**LINCOLN/LANCASTER COUNTY PLANNING STAFF REPORT**

**-REVISED REPORT-**

**PROJECT #:** Change of Zone No. 07018 - Glynoaks Plaza

**PROPOSAL:** From AG and R-3 to R-3 PUD

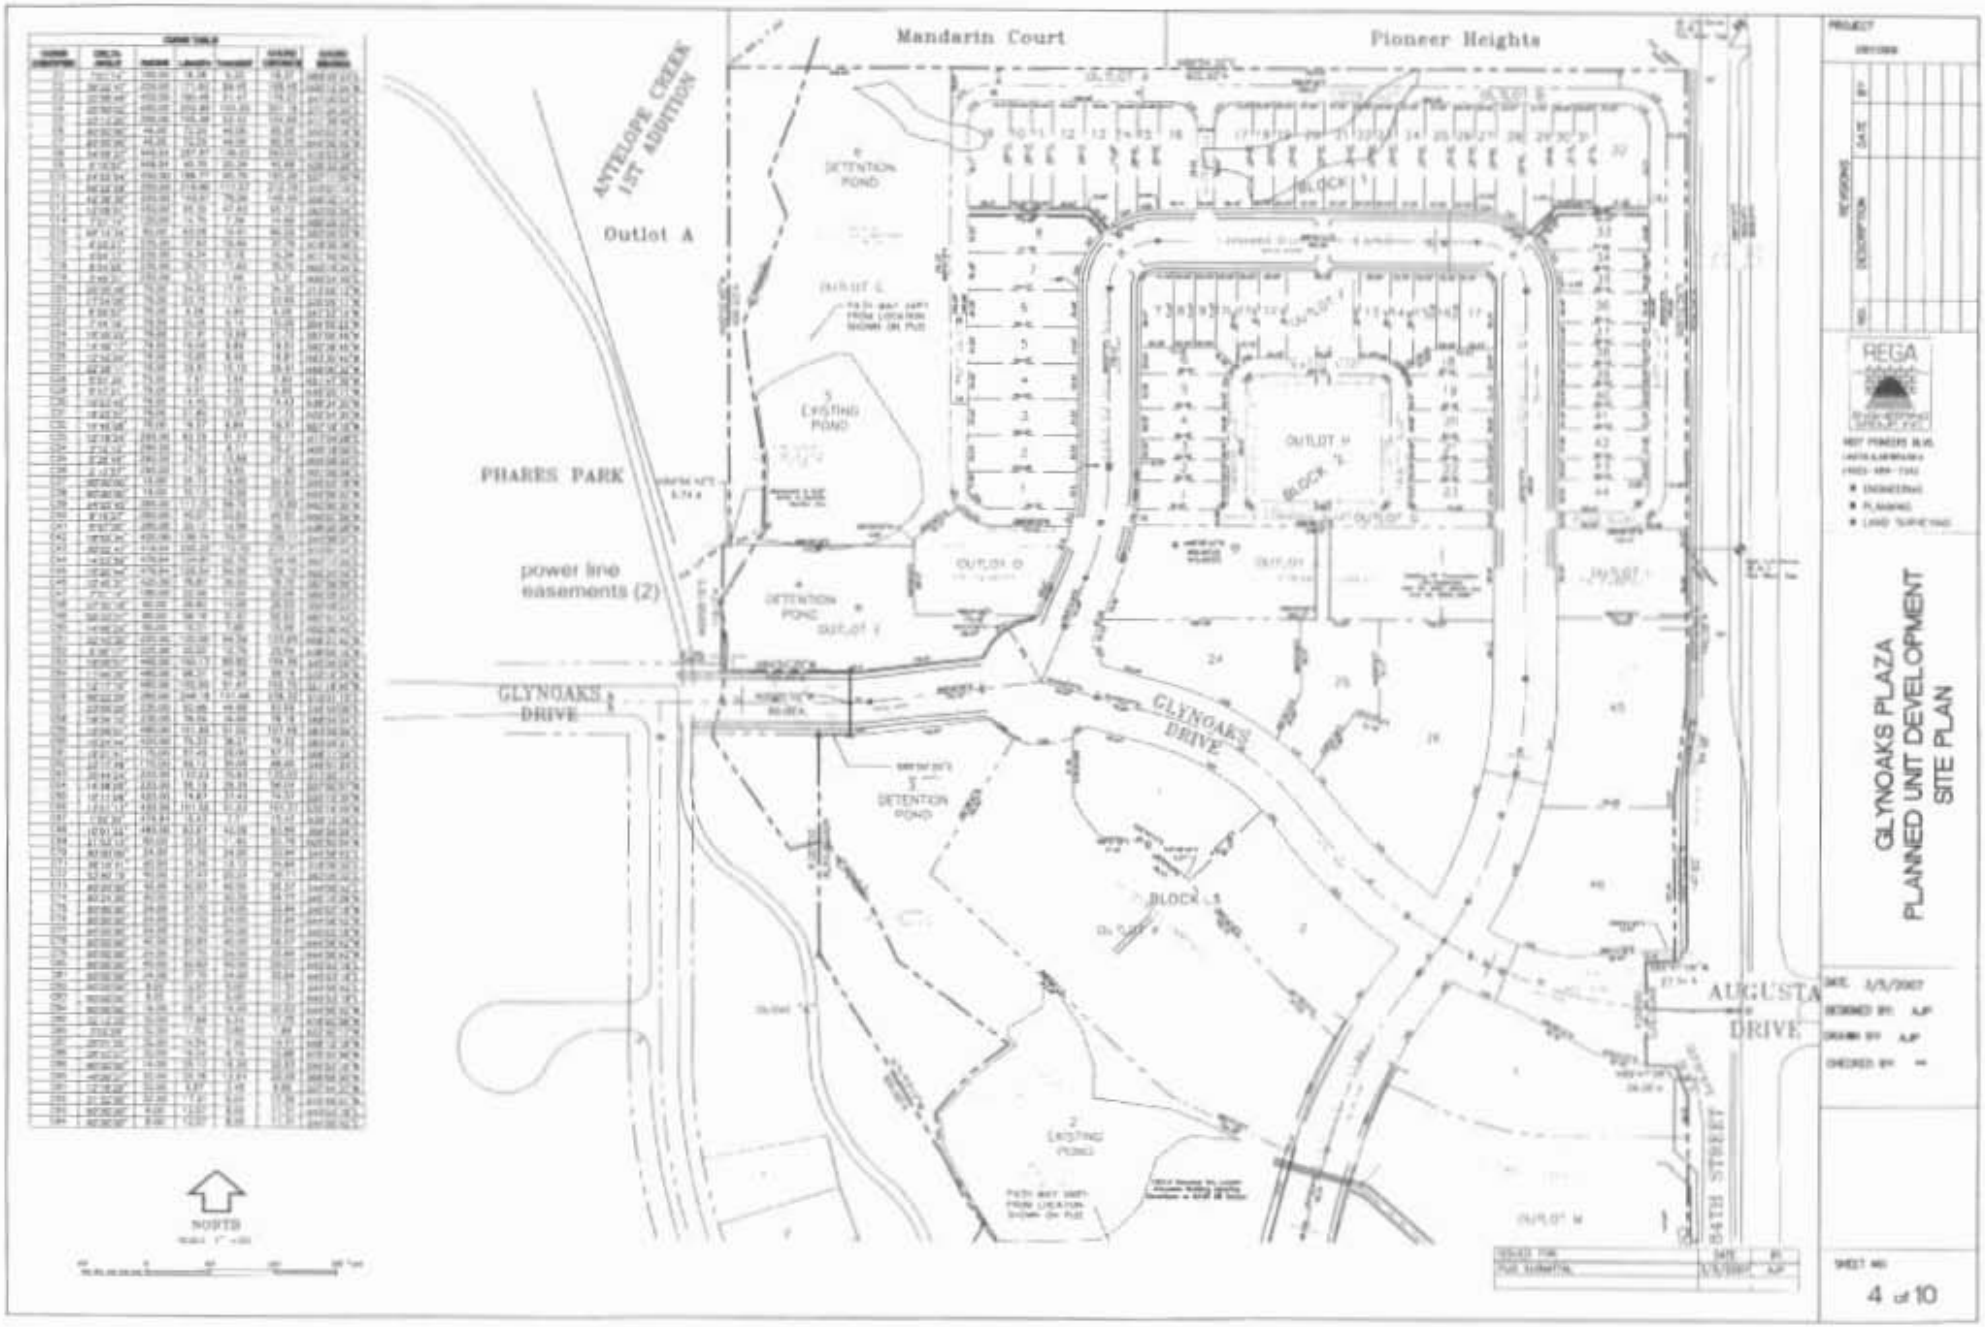
3.1.1 Provide the correct legal description on Sheet 1 of 10.

3.1.2 Delete the words "the vicinity of" from General Note #5.

3.1.3 Change "discontinued" to "rescinded" in General Note #11.

3.1.4 Revise General Note #13 to state “Eaves may project over building envelopes, but not lot lines. Awnings and canopies may project into the right-of-way, however no posts or support structures affixed to the ground for awnings or canopies may be built in the right-of-way.

3.1.6 Revise General Note #14 to state “Street trees along Glynoaks Drive in the town square may vary from street tree design standards as appropriate, but must be shown and approved by the Parks and Recreation Department at the time of final plat.

SHEET NO.
5 of 10

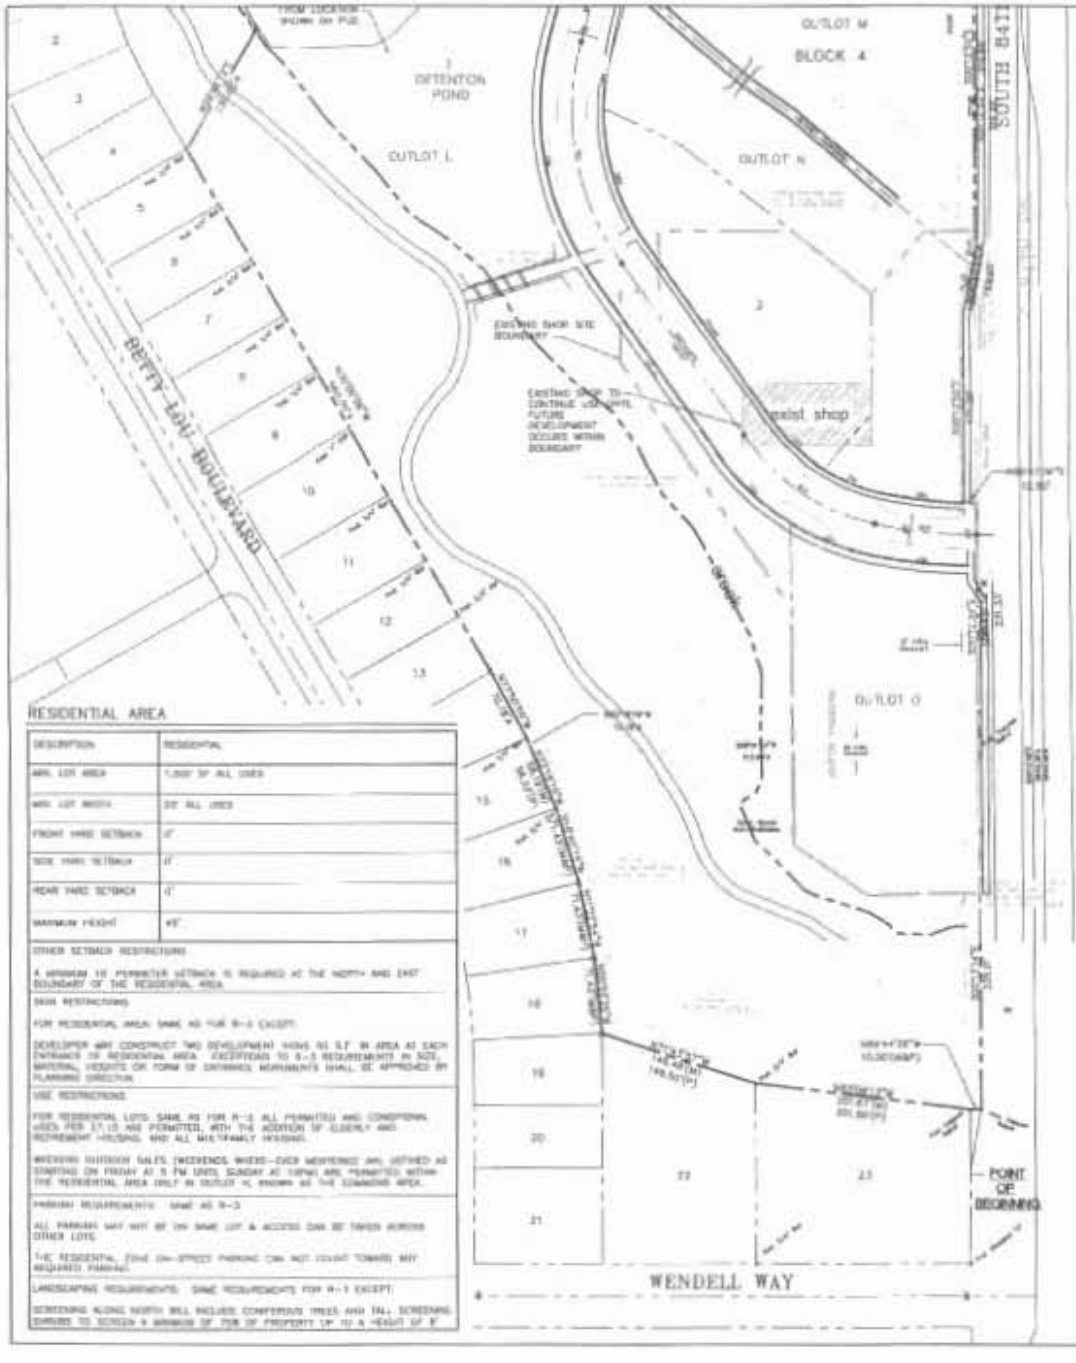
3.1.12 Revise the sign restrictions in the residential area on Sheet 5 of 10 to state “Developer may construct two ground signs 50 s.f. in area at each entrance to the residential area. Exceptions to the R-3 sign requirements regarding size, location, material and height may be approved by the Planning Director by administrative amendment.

3.1.13 Revise the parking requirements in the residential area on Sheet 5 of 10 to state “Required parking may be located on a different lot with access easements granted to provide access.

3.1.14 Delete “The residential zone on-street parking cannot count toward any required parking” from the parking requirements in the residential area on Sheet 5 of 10.

3.1.15 Revise the landscaping requirements in the residential area on Sheet 5 of 10 to state “A 75% screen at least 8' in height at maturity consisting of coniferous trees and deciduous shrubs will be planted along the north boundary of the PUD.

3.1.16 Revise the sign restrictions in the commercial area on Sheet 5 of 10 to state “Signs per the B-2 zoning district are allowed and

are not required to be shown on this plan but at the time of sign permits. Pole signs are prohibited"

3.1.17 Delete the statements from the sign restrictions in the commercial area on Sheet 5 of 10 that say "Pole signs and monument signs are prohibited", and "Maximum pedestrian sign size is 8 s.f. Canopy and projecting signs may be adjusted by the Planning Director."

3.1.18 Revise the sign restrictions in the commercial area on Sheet 5 of 10 to state "The size and location of canopy, pedestrian and marquee signs, including projections into the public right-of-way, may be adjusted by the Planning Director by administrative amendment.

3.1.19 Revise the use restrictions in the commercial area on Sheet 5 of 10 to state "No use permit shall be required for the commercial area. All uses permitted in the commercial area shall be those uses allowed in the B-2 district including residential on any level and outdoor weekend sales, except all industrial uses, drive-through facilities, service stations and convenience stores with gas pumps are prohibited, with the exception of Lot 2, Block 4 where a drive-thru facility associated with a bank is allowed. Outdoor sound amplification shall not be permitted between 10:00 p.m. and 8:00 a.m. Exterior lighting facing residential areas shall use cutoff fixtures, except parking lot lighting which shall comply with the applicable Design Standards. In other areas lighting shall otherwise comply with the applicable Design Standards."

3.1.20 Revise the parking requirements in the commercial area on Sheet 5 of 10 to state "Shared/Joint parking is provided in the commercial area. The off-street parking requirement is one parking space per 600 square feet of floor area. Weekend outdoor sales events can occupy up to 40 parking spaces in parking lots located south of Glynoaks Drive at any one time."

3.1.21 Revise the landscaping requirements in the commercial area on Sheet 5 of 10 to state "Street trees in are not shown but shall be submitted at the time of final plat with adjustments to vary the size, spacing and location approved by the Parks and Recreation Department."
